Transmission Expansion Advisory Committee – FirstEnergy (ATSI) Supplemental Projects

August 4, 2026

Changes to the Existing Supplemental Projects

ATSI Transmission Zone Supplemental s2237.2 Scope Change

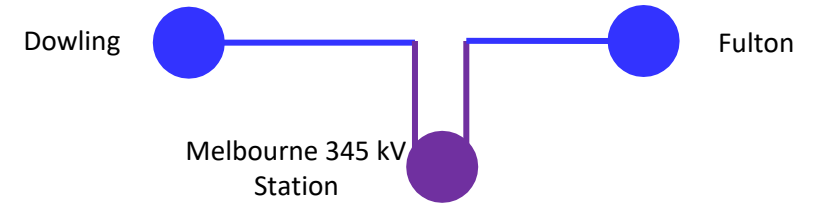
- Construct a new 345 kV four breaker ring bus.
- De-energize approx. 1.0 mile of the Dowling-Fulton 345 kV line.
- Construct 8.7 miles of 345 kV line to connect the Dowling 345 kV line into the new 345 kV station with 954 ACSR 45/7 bundled (2 conductors per phase). New 345 kV line to be built and share structures with the Delta-Wauseon 138 kV line and Delta – Fulton 138 kV line.
- Replace the wave trap at Dowling 345 kV line to ensure the Dowling-New 345 kV station 345 kV transmission line is the limiting element.
- Re-terminate the Fulton 345 kV line that serves North Star Steel Sydney into the new 345 kV station.
- Provide two feeds from the new 345 kV station to North Star Steel Sydney with 954 ACSR 45/7 bundled (2 conductors per phase).

- Model North Star Sydney Steel Substation at Melbourne Substation due to substation proximity.

Reason for Scope Change:

- Model change is to align with FirstEnergy modeling standards due to proximity of Melbourne Substation to customer.

Revised Solution:

Dowling-Melbourne 345 kV Station Rating:

- 1542/1878 MVA SN/SE, 1746/2225 MVA WN/WE

Fulton-Melbourne 345 kV Station Rating:

- 1542/1878 MVA SN/SE, 1746/2225 MVA WN/WE

Estimated Project Cost: \$67M

Projected In-Service Date: 6/1/2024 5/14/2027
